Sizewell C (SZC)

Planning Inspectorate Reference: *EN010012*

East Suffolk Council comments on Deadline 8 submissions from the Applicant

9.13 Sizewell C Coastal Defences Design Report [[REP8-096](#)]

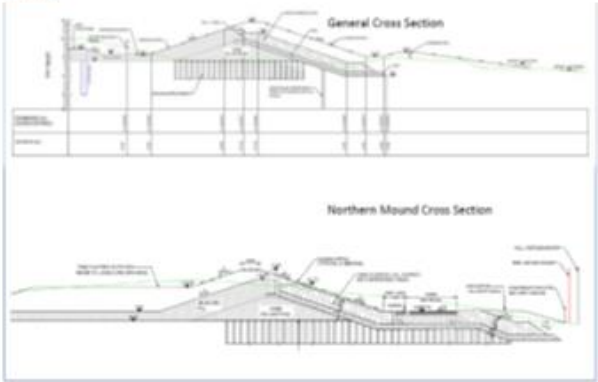
2.2.3	<p><i>The modified sea defence comprises the following...</i></p> <ul style="list-style-type: none"> <i>Up to 2m thickness of landscaping over the revetment on the seaward slope giving a maximum total height of 14.6m OD.</i> <i>An adaptive sea defence height of +16.4m OD excluding landscaping with a</i> 	This issue is returned to later in this critique. Our concern is how these landscaping features are allowed for both in terms of their influence on hydraulic performance of the revetment and/or the logistics/practicality of their removal.	Further information: more detailed questions to follow later in the critique.

<i>maximum height of +18.0m OD including landscaping</i>		
	<i>Fig 3.1</i>	<p>Figure 3-1 - Sea Defence Layout</p> 	<p>The north end of the HCDF now shows the realigned and more retreated position of the HCDF.</p> <p>The south end overlap with Sizewell B has moved seaward possibly beyond the easting of the BLF promontory.</p> <p>The 'typical' section location is not at the most critical point that would be either the BLF or the Southern kick-out.</p> <p>The SCDF width varies and the seaward line is not straight / even. Is it defined by the MHWS countour?</p>	<p>Further information and clarifications sought:</p> <p>Provide additional sections at BLF and Southern extent showing Temp HCDF, HCDF and SCDFs plus unconstrained shoreline profiles at 2020, 2050, 2080, 2110 and 2140. This has not been provided.</p> <p>Typical XS is at 264015mN. In figure 3.5 a 2014 beach profile is used.</p> <p>Provide legible underlying bed contours across the whole frontage, not just confined to the north end. Extend to show a portion of Minsmere. This has not been provided.</p>

<p>Provide a legible scale and identify the easting/northing lines. This has not been provided.</p> <p>Why do the south ends of the HCDF and SCDF not coalesce with the structure and alignment of the Sizewell B bund? How has the SCDF width and seaward extent been determined? Explanation has now been provided.</p> <p>Is the HCDF toe detail at the BLF at the Adapted profile level (-1.5m ODN)?</p> <p>Explain why the temp piled defence moves outside the perm defence footprint at the Northern end. Temp HCDF removed at northern end.</p>
--	--	--	--	---

<p>Light temp piling to protect SSSI from contamination during works.</p> <p>Will the temporary piled defence outside the footprint be fully removed when decommissioned? Light piling - yes.</p> <p>We understand that the Sizewell C coastal defence feature is not allowed to make contact with the Sizewell B coastal defence, as the latter is a live operational power station. However, according to the drawing, the two defences <u>are</u> in contact. Please advise / provide the redesign.</p> <p>Further comment is given later in the review.</p>
--	--	--	--	---

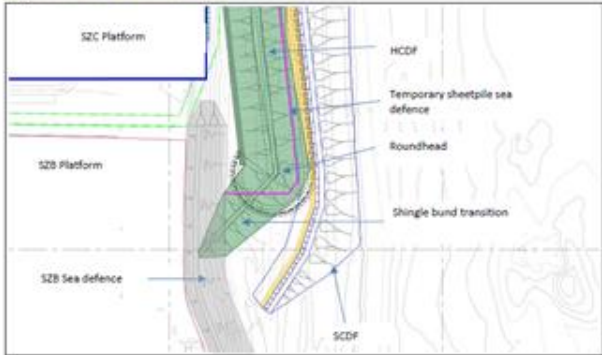
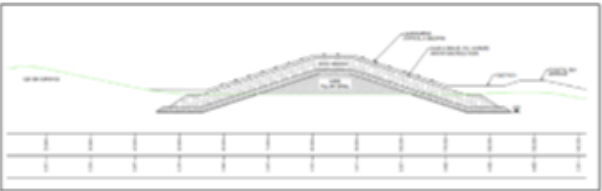
3.4.3	<p>Figure 3-5 – Permanent Sea Defence, Typical Cross-section and Northern Mound</p> 	<p>3.4.3 The seaward toe of the sea defence extends approximately 3m further east (seaward) than in the original DCO submission. This change in seaward extent between the current design and the May 2020 version is driven by the change in crest level of the Permanent Sea Defence (+10.2mOD in May 2020 submission, increasing to +12.6mOD in the change submission) and the minimum 5m standoff to the outer Sizewell C site fence that fixes the landward (western) boundary. This security standoff represents a minimum value that was already assumed in the May 2020 DCO application in order to minimise the Sizewell C footprint. The increase in crest height is due to the increase in climate change allowance between UKCP09 and UKCP18 and the extended design life of the sea defence.</p>	<p>Clarification: The section is designed to avoid the RSPB boundary. Please show section on plan. How does this feature “rotate” (roundhead) to align with the now realigned HCDF at the north end?</p>

3.3.3	<p><i>The seaward toe of the sea defence in the January 2021 Change submission extends</i></p>	<p>See related comment in 3.9.11.</p>	<p>How far has the HCDF toe extended seaward at</p>

<i>approximately 8m further east (seaward) than in the original DCO submission. This change in seaward extent is driven by the change in crest level of the Permanent Sea Defence (+10.2mOD in May 2020 submission, increasing to +12.6mOD in the change submission) and the minimum 5m standoff to the outer Sizewell C site fence that fixes the landward (western) boundary.</i>		amended south end Sizewell B overlap detail? Assumed 26m.

3.3.4	<i>The design considers a number of constraints and interfaces, including: Minimising seaward extent of HCDF commensurate with engineering function.</i>		Explain what design changes have been applied since May 2020 that have moved the seaward extent of the works to landward or limited its movement to seaward?
10	Tbl 3.1	<i>Reasonably Foreseeable. Long-term coastal erosion of 0 – 20m</i>	<p>20m / 120 years = retreat rate of 0.17m/yr.</p> <p>At 1:10 slope (tbc) = up to 1.7m drop in level at current MHWS contour as beach profile moves landward.</p> <p>This retreat rate differs significantly from assumptions in [REP7-101] 3.1.1.2 that identifies a range of 1.01 to 2.23 m/yr as worst case scenarios.</p>	Add forecast eroded baseline beach profiles, extrapolated to years 2050, 2080, 2110 and 2140 to all drawings that are relevant to the assessment of HCDF toe resilience and SCDF management. This is necessary to demonstrate how a retreating baseline shoreline will affect SCDF

degradation and replenishment actions. Why does the RF erosion rate differ from the range used in [REP7-101] ?
10	Tbl 3.1	<i>Credible Maximum. Long-term coastal erosion of 20m to 40m</i>	<p>40m / 120 years = retreat rate of 0.33m/yr.</p> <p>At 1:10 slope (tbc) = up to 3.3m drop in level at current MHWS contour as the beach profile moves landward.</p> <p>This retreat rate differs significantly from assumptions in [REP7-101] 3.1.1.2 that identifies a range of 1.01 to 2.23 m/yr as worst case scenarios.</p>	<p>Add forecast eroded baseline beach profiles, extrapolated to years 2050, 2080, 2110 and 2140 to all drawings that are relevant to the assessment of HCDF toe resilience and SCDF management. This is necessary to demonstrate how a retreating baseline shoreline will affect SCDF degradation and replenishment actions.</p> <p>Why is the 2.23 m/yr worst case erosion rate identified in [REP7-101] not used as the Credible Maximum retreat value in this report?</p>

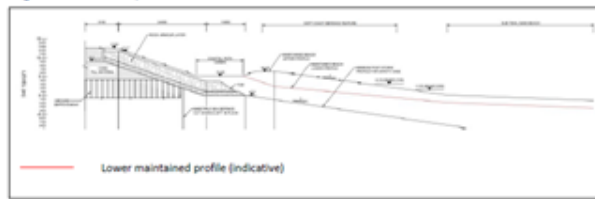
12	3.4.1	<i>The HCDF comprises a rock revetment with a double armour layer of 6 to 10 tonne quarried armour stone rock over a rock underlayer,</i>	<p>Layer thicknesses based on this grading are:</p> <p>Mean 8 tn rock has Dn50 of ~1.45m.</p>	Confirm that the upper surface of the rock layer at the HCDF toe is at 4m ODN

<i>granular core and ground improvements (where needed).</i>	2 layer thickness = $1.8 * 1.45 = 2.6\text{m}$ plus underlayer of $\sim 1\text{m}$?. Total thickness 3.6m ? Looks like $\sim 4\text{m}$ ODN on profile.	that is $\sim 1\text{m}$ below the existing 5m berm and above the level of the shingle back beach landward of the berm. No response but confirmed in new drawings.
12	Table 3-2	Re armour size: <i>A concrete armour solution is frequently considered when a larger rock size is required. A concrete armour solution is not required for the HCDF but may be required for the Adaptive Design.</i>	This is not very informative. Please provide the rationale for selecting very large rock armour over concrete armour units in this case. Generally, concrete armour units can be placed to a steeper slope than rock, thus reducing footprint (in fact the steeper slope can be preferred to obtain higher friction forces between units). It is understood that a higher crest may be required to obtain the target overtopping limit. However, we would like to see that this topic has been assessed and the reasoning for rock or concrete armour properly addressed. Regarding the suggestion of using an armour solution for the Adaptive Design, we would question the	Further information is required as explained in the comment box to the left.

<p>suitability of using the massive rock armour as a bedding layer for this, given the respective size of the two armour types.</p> <p>Please be aware that our concern is that opportunities to reduce the HCDF footprint may be missed and hence we are questioning certain aspects of the design in this respect only. We are not criticising the design per se.</p>	
13	Fig 3.5	Permanent Sea Defence, Cross-Sections (Baseline and Adaptive)		
			Buildability	<p>Clarification / further information:</p> <p>The same circumstances for which the Adaptive Design would be built (narrowing shore) would suggest that construction could be challenging.</p> <p>It is relevant to the impact on coastal processes to know how the Adaptive Design</p>

including dredging might be constructed, e.g. as a marine operation, or other? No detail provided.
15	Fig.3-7	<p>Figure 3-7 - Permanent Sea Defence, Cross-Sections (Baseline and Adaptive)</p> 	<p>The section shows landscaping treatment on top of the adaptive additional armour layer.</p> <p>This could be at variance with the former design and with references elsewhere in the present document version.</p>	<p>Please confirm, is this inclusion deliberate or an oversight. If deliberate it would attract the same concerns as expressed on page 3 Fig. 3.3</p>
13	3.4.4	<p><i>Numerical modelling of the beach storm response indicates that the toe of the HCDF would not be at risk of being exposed in a design basis 1 in 10 000 year storm event provided it is set at 0.0m OD or lower. This modelling is based on the 2140 climate change parameters (RCP8.5, 95%ile).</i></p> <p><u><i>These profiles will be subject to further study and modelling work during the detailed design.</i></u></p>	<p>See comments on possible retreat and lowering in table 3.1.</p> <p>There is potential for further changes that may move the toe lower and seaward.</p>	<p>Why is there no reference to a retreated future shoreline position (up to 2140?) nor assumptions on presence/absence of a SCDF?</p> <p>What is the basis of the modelling and hence justification of the toe depth. For example, if storm induced beach scour then how does this figure with the long term beach lowering (as above mentioned), the local geology, and scour arising</p>

17	Fig 3.8	<p>Figure 3-8 – SCDF, Indicative Lower Maintained Profile</p> 		
17	3.7.11	The lower maintained beach profile shown in red on Figure 3-8 and Appendix A.4 is required		Does the Applicant guarantee to invest in beach

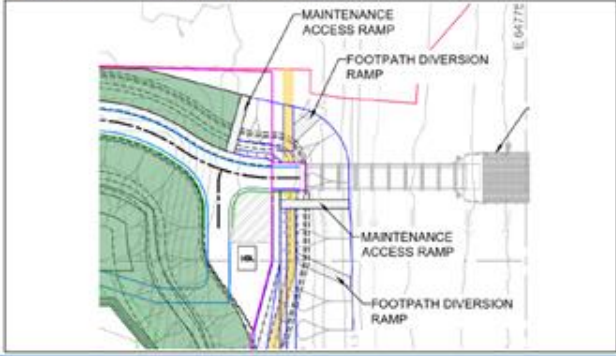
<i>to maintain the safety case for the sea defences such that the toe of the HCDF at +0.0m OD is not exposed in a design basis storm event. <u>Again, the exact shape/volume of this profile will be determined at detailed design stage.</u> The SCDF would be recharged to ensure that the lower maintained profile is not realised.</i>		management measures that will sustain the SCDF at a level above the red line unless / until the HCDF is removed? Update this drawing to show the impact of erosion forecasts in table 3.1 on an unconstrained shoreline and on SCDF maintenance actions.
24	3.10.28	<i>The soft sea defence terminates at the maintenance ramp in the BLF area, as seen in Figure 3-14.</i>	The SCDF must function in an integrated fashion with the beaches to north and south of the Sizewell C site. It should not be constrained by a terminal groyne-like ramp structure.	Clarify position with regard to connectivity of SCDF with the northern shoreline.

24	3.10.29	<i>The maintenance access ramp on the south side of the BLF would be buried by the SCDF but could be uncovered when required for use.</i>	Ditto above.	Will the ramp crest be below the recharge trigger profile for the SCDF? If not it may block sediment movement.
22	3.10.14	<i>3.10.14 The infilling will likely use sediment within the same particle size range as the native beach face. Use of pebbles and cobbles towards</i>	We welcome this acknowledgement of the influence of the recharge particle size on the behaviour of the	Confirmation sought that particle size distribution of the SCDF will match that of

<i>the coarser end of the size spectrum, would provide enhanced longevity and reduce the frequency of subsequent recharge but for geomorphological, ecological, landscaping reasons the default position is that the SCDF will match the native particle size. BEEMS technical report [REP7-101], gives further details of the proposed beach recharge material.</i>	SCDF in relation to the coastal geomorphology. It should be noted however, that the native material should match not just the source of material (native) but also its particle size distribution to the extent that normal retreat of the SCDF is not unnaturally stalled (held back) in relation to that of the adjacent as this would eventually result in recessed shorelines. The latter would have a negative impact on the longshore transport regime by creating a blockage both north and south of the HCDF.	the native material to avoid the development of recessed shores and negative impact on longshore transport.

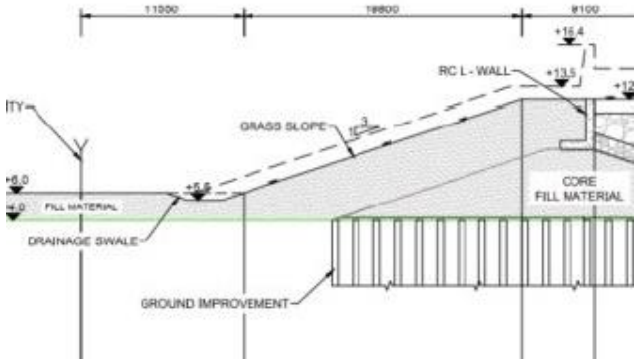
3.8	<i>Adaptive design.</i>		
	3.8.2	<i>Owing to the inherently uncertain nature of climate change, it is recognised that the RF climate change scenario may be exceeded, leading to more onerous climate change effects becoming prevalent. ONR and EA guidance therefore requires that the sea defence be capable of adaptation to a Credible Maximum (CM) sea level rise. The CM scenario is defined as the H++ climate change scenario as defined in UKCP09, as UKCP18 refers back to the</i>	The principle is understood together with the general approach of an Adaptive Design. However, the driver for the Adaptive Design appears to be substantially/wholly based around sea level rise. Coastal morphological changes will need to be treated with equal importance, being key to the survival of the HCDF (being what is sits on).	Further information sought on the inclusion of coastal processes in the design basis for the Adaptive Design. This would cover both security of the HCDF (founding), and the impact on coastal processes, i.e. continuity of sediment transport.

<i>UKCP09 estimates and does not provide updates estimates (refer to section 3.3.4a) et seq). <u>The sea defences have therefore been designed to allow for future adaptation to accommodate the CM scenario, should it develop. The modified defences that would be delivered through implementing these future adaptations is termed the “Adaptive Design”.</u></i>

3.8.3	<i>Figure 3-9 shows the Adaptive Design, with tidal levels shown reflecting RF sea level rise to 2140. A larger-scale section is provided at Appendix A.5. <u>The Adaptive Design of the HCDF would retain the SCDF in front of it.</u></i>	A SCDF to seaward of an Adaptive profile would be ~15m further east than for the basic HCDF design and would be location in the intertidal beach.	Demonstrate that retention of a SCDF to seaward of an Adaptive profile is viable.
		<p>Figure 3-9 - Adaptive Design, Typical Cross-section of HCDF</p>

3.8.4	<i>In the Adaptive Design, concrete armour units would be overlaid on the previously placed rock revetment, and the toe section extended further seaward to a lower level. A toe level of -1.5mOD would be required, i.e. 1.5m deeper compared to when the proposed HCDF is originally built.</i>		Explain the basis of the -1.5m toe level with the Adapted design. This has not been provided.
